**Technical Bulletin**  
**No. K200-004**Issued on  
May, 7, 1991**Subject:** Spare Parts List for K200 ISDN Kit**Model(s):** K200 ISDN Kit**FAX T.S. Section T.S. Department**  
**Manager**  
H. Motojima**Classification**

# Technical Bulletin No.K200-006

**Noise may be generated around the Z51 idle gear.**

**Model(s):** FAX7000(D), 7000L(Digital G4)  
i-6765, 6865

**From the parts catalog, page 1-22, 22 (item 41)**

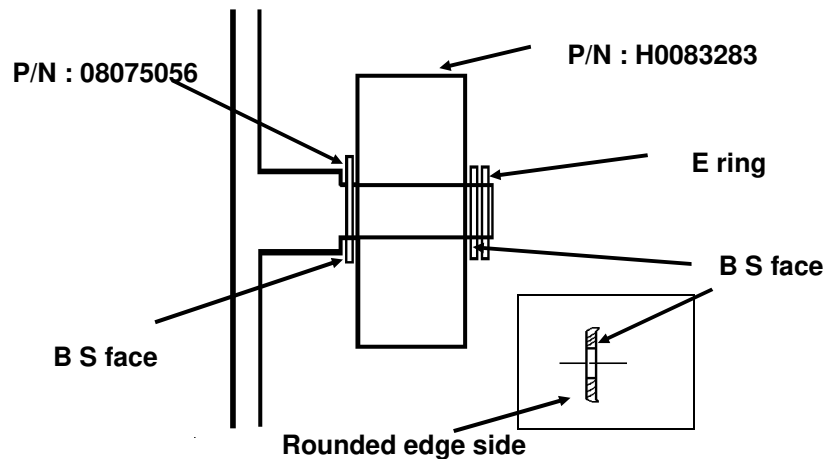
**[Symptom]** Noise may be generated around the Z51 idle gear while the main motor is moving. Also, paper jam may occur.

**[Cause]** The shaft for the Z51 idle gear have become worn. This problem may occur in machines whose printer counter is more than 70000.

A washer has been added between the gear and the E ring, and the inside of the gear has been changed from a bearing to a bushing.

- | old                           | new |

| • H0083247 x 1 → H0083283 x 1 |     |
| • 08075056 x 1 → 08075056 x 2 |     |

Please change the following parts at the PM for machines that are not modified. According to the above figure.

H0083283	Main Drive Idler - Z51	1pc
08075056	Washer 8.1 x 14	2pcs

**Note:** Please be careful with the washers at both sides of the gear when you modify the machine in the field, because they have the direction. The rounded edge side (opposite to BS face) should be attached to the gear direction. (Refer to the above illustration.)
